**HI-STORM 100 CERTIFICATE OF COMPLIANCE 72-1014**

**LICENSE AMENDMENT REQUEST 1014-1**

**HI-STORM 100 CASK STORAGE SYSTEM  
DOCKET NO. 72-1014  
TAC NO. L23082**

**HOLTEC RESPONSES TO NRC REQUEST FOR ADDITIONAL INFORMATION**

FIGURE 4.3-1: HOLTITE<sup>TM</sup> THERMAL CONDUCTIVITY CONSERVATISM

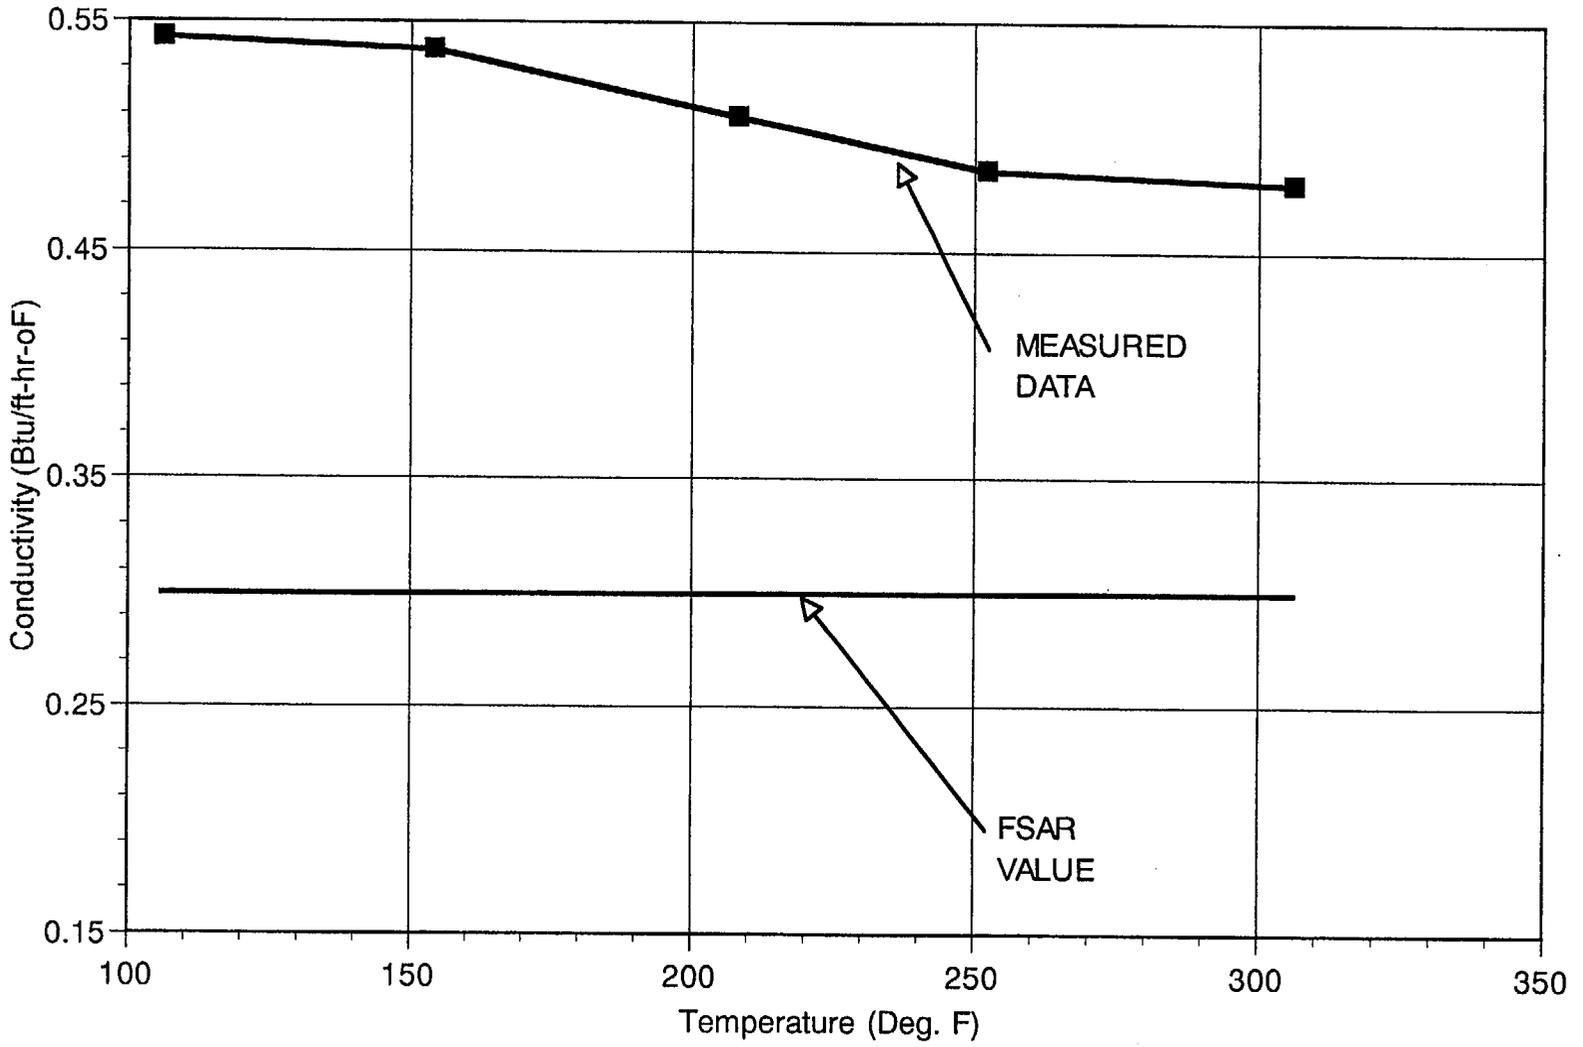
Provide clarification regarding the temperature range where the postulated conductivity, as noted in SAR Section 4.2 for Holtite is valid. Additionally, verify that the lower bound is appropriate for the temperature range that this material is exposed to during normal and off-normal accident conditions.

The Holtite™ neutron shielding material is used in the 125 ton HI-TRAC transfer cask lid (See FSAR Figure 1.2.9). For normal and off-normal conditions (FSAR temperature limit of 300°F), a lower bound Holtite thermal conductivity (K) of 0.3 Btu/ft-hr-°F is postulated in the thermal evaluation of HI-TRAC 125 transfer cask. This, as we show below, imputes a large conservative bias to the material's heat dissipation characteristics. In Figure 4.3.1 provided herein, we present a comparison of the Holtite™ measured thermal conductivity data<sup>a</sup> with the FSAR value over a temperature range of 106°F to 306°F. The following observations are applicable:

FIGURE 4.12-1: HI-STORM BLOCKED INLET DUCTS TRANSIENT PEAK CLAD TEMPERATURE HISTORY @ 28.74 kW

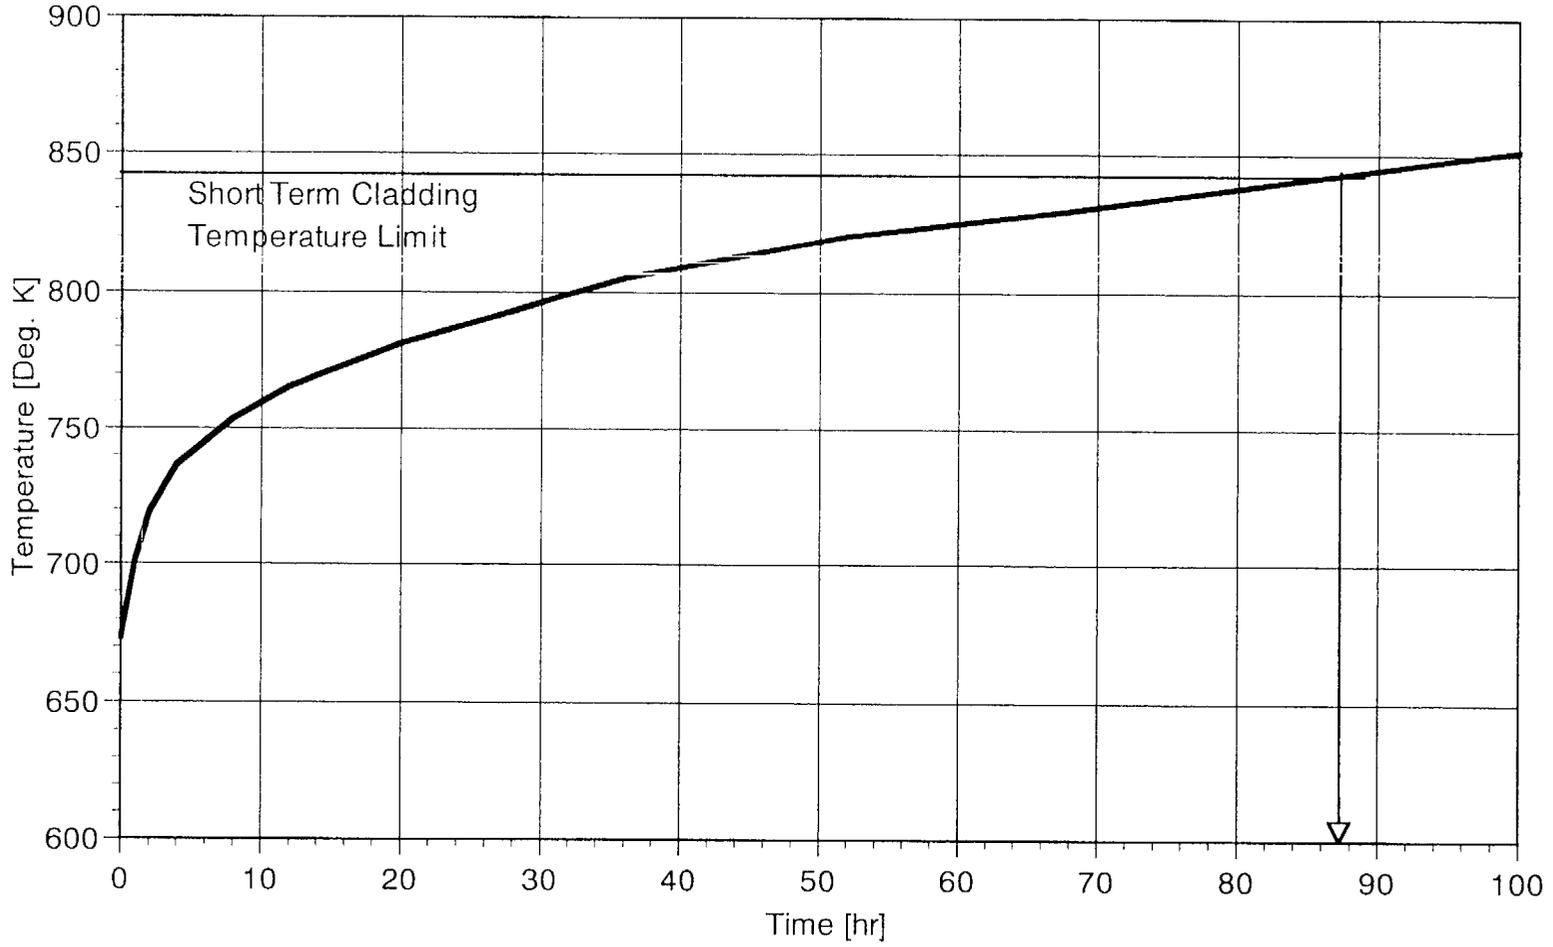
Provide a technical rationale for why it is acceptable to allow temperature limits for non-fuel clad materials to be exceeded. For users with site-specific design basis which includes an event that results in blockage of air inlets or outlets for an extended period of time, the proposed TS (Appendix B, 3.4.9) only requires verification the fuel clad temperature limits are not exceeded.

We no longer subscribe to the position that only the temperature limits for the fuel cladding should be applied in establishing the permissible duration (say,  $\tau^*$ ) for which all inlet or outlet ducts can be blocked. Specifically, the section average temperature of the shielding concrete (350 °F per Table 2.2.3) should also be considered in establishing  $\tau^*$  (see also Response 4.10 regarding concrete radiation shielding performance at elevated temperatures). The proposed TS (Appendix B, 3.4.9) that calls for the temperature of the fuel cladding as the governing parameter is based on the implicit assumption that the cladding temperature limit will be reached before the corresponding limit for the section average concrete temperature is approached.
